ATTACHMENT 2 TO AEP:NRC:1071F
DESCRIPTION OF PROPOSED LICENSE CONDITIONS AND
T/S CHANGES, AND 10 CFR 50.92 SIGNIFICANT
HAZARDS CONSIDERATION ANALYSIS

ATTACHMENT 3 TO AEP:NRC:1071F
PROPOSED LICENSE CONDITIONS AND T/S PAGES

Figure 5.6-1: Donald C. Cook Nuclear Plant Schematic for Fuel Storage Racks Interface Boundary Between Regions 1 and 2

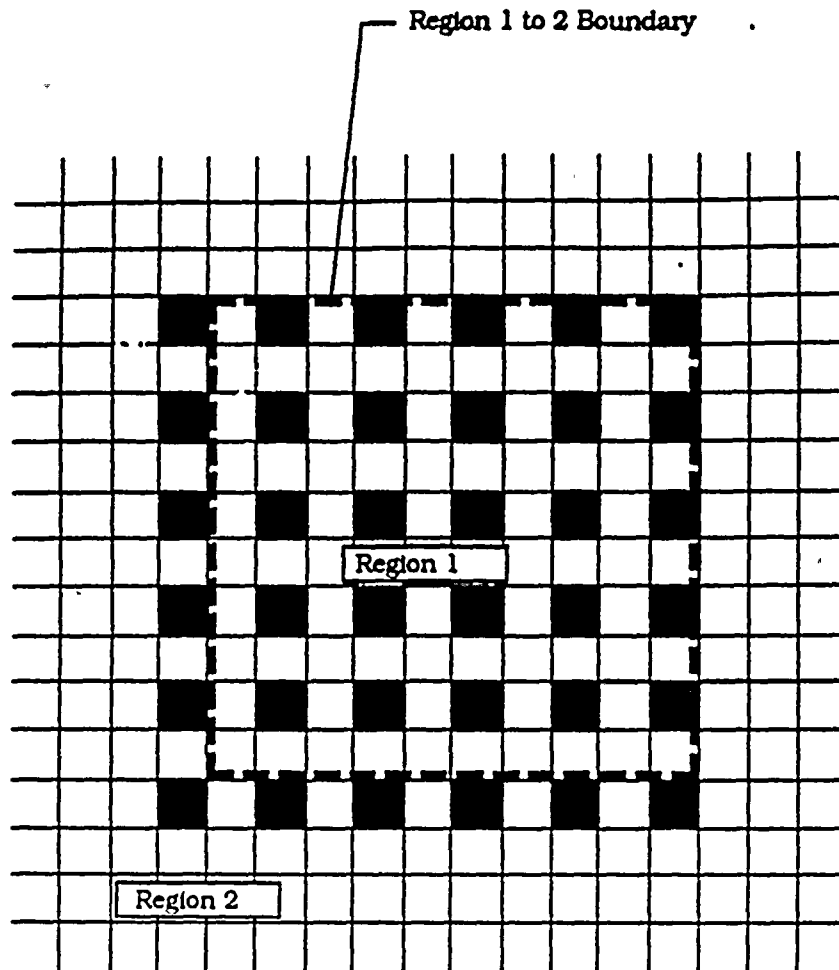
Subparagraph c.2 addresses the boundary conditions between the Region 1 of subparagraph c.1, and the rest of the spent fuel storage racks, called Region 2. This boundary condition is that the three-out-of-four storage requirement for Region 1, must be carried into Region 2 by, at least, one row. This boundary condition is illustrated in a new figure, Figure 5.6-1 entitled, "Donald C. Cook Nuclear Plant Schematic for Fuel Storage Racks Interface Boundary Between Regions 1 and 2."

- a. A k_{eff} equivalent to less than 0.95 when flooded with unborated water,
- b. A nominal 10.5 inch center-to-center distance between fuel assemblies placed in the storage racks.
- c. 1. A separate region within the spent fuel storage racks (defined as Region 1) shall be established for storage of Westinghouse fuel with nominal enrichment above 3.95 weight percent U-235 and with burnup less than 5,550 MWD/MTU. In Region 1, fuel shall be stored in a three-out-of-four cell configuration with one symmetric cell location of each 2 x 2 cell array vacant.
2. The boundary between the Region 1 mentioned above and the rest of the spent fuel storage racks (defined as Region 2) shall be such that the three-out-of-four storage requirement shall be carried into Region 2 by, at least, one row as shown in Figure 5.6-1.

Figure 5.6-1: Donald C. Cook Nuclear Plant Schematic for Fuel Storage Racks Interface Boundary Between Regions 1 and 2

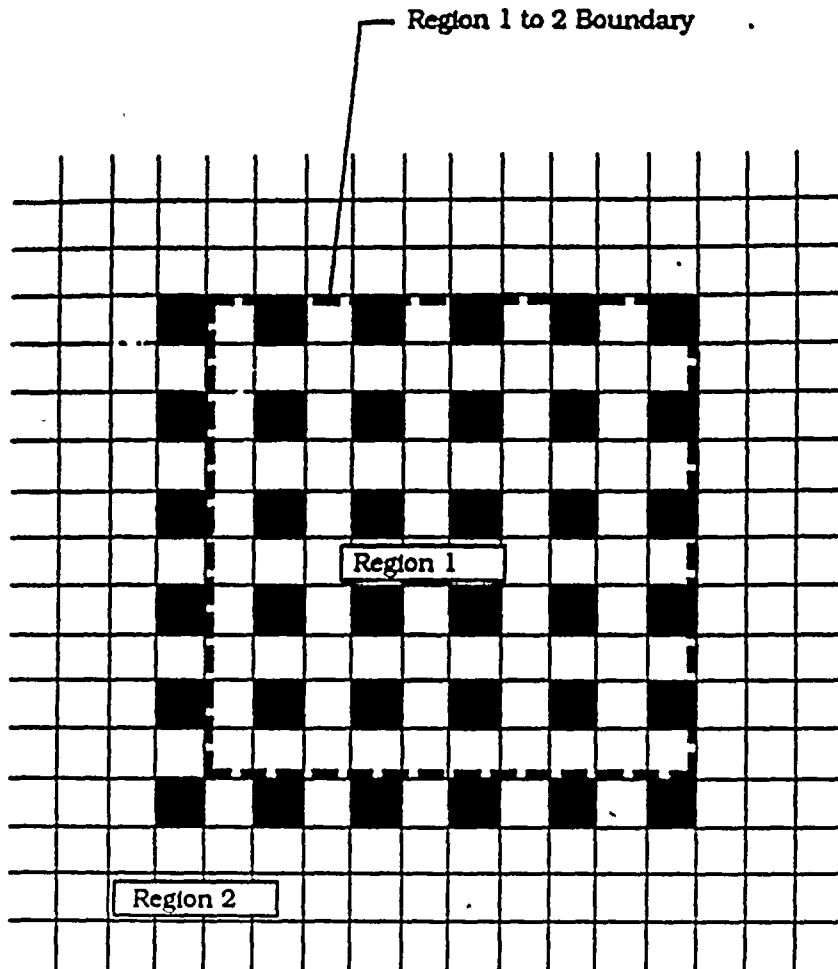
2. The boundary between the Region 1 mentioned above and the rest of the spent fuel storage racks (defined as Region 2) shall be such that the three-out-of-four storage requirement shall be carried into Region 2 by, at least, one row as shown in Figure 5.6-1.
